City of Mississauga
Corporate Report

PUBLIC MEETING RECOMMENDATION REPORT (WARD 2)

Official Plan and Zoning By-law Amendment applications to permit 180, three storey, back to back townhouses in 12 development blocks

2620 Chalkwell Close, east side of Winston Churchill Boulevard, north of Truscott Drive and south of Sandgate Park

Figure 5: Deployment of a 45-degree angular plane line marked in red to demonstrate the scale of massing for proposed Townhouse Blocks F and L in relation to proposed setbacks to existing residential rear yards.

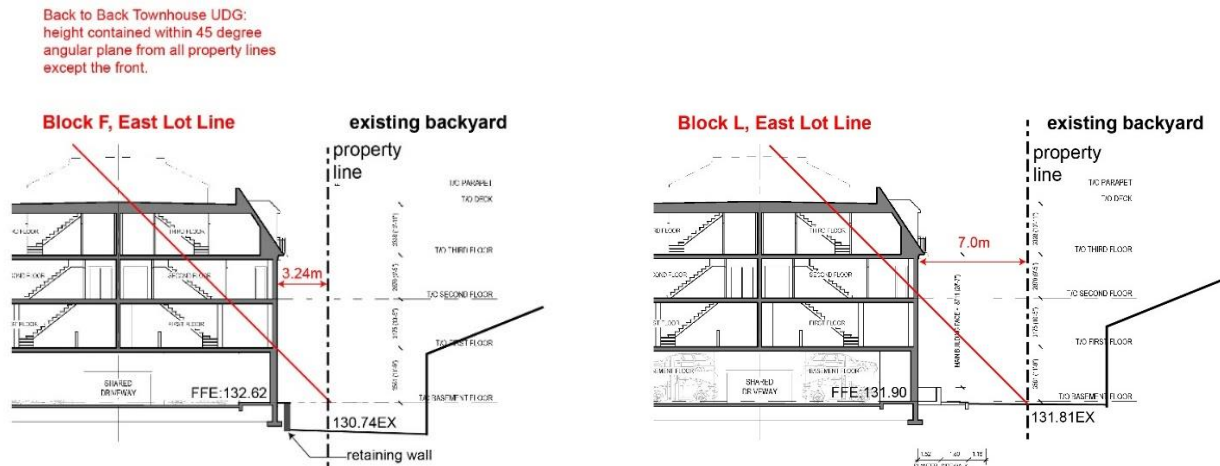
The addition of rooftop terraces creates a condition similar to five storey townhouse that would require sufficient stepbacks, additional screening, increased yard setbacks and increased landscape buffers to mitigate any adverse impacts.

MOP policies and associated design guidelines encourage development standards that ensure compatibility with adjacent low rise built forms. To further aid transition between different built forms, the City's townhouse design guidelines denote that buildings over 3 storeys should consider stepbacks and sloped roofs to reflect similarities with the surrounding built form character. Additionally, the use of a 45-degree angular plane from rear and side yards is appropriate to measure the proposal's transition to neighbouring dwellings. Figure 5 below illustrates the obstruction of the 45-degree angular plane as submitted in proposed development.

Without the implementation of building stepbacks on the top floor of the townhouses, the proposed reductions to landscape buffers and building setbacks, the proposed development does not consider the scale of the townhouse blocks to the surrounding context.
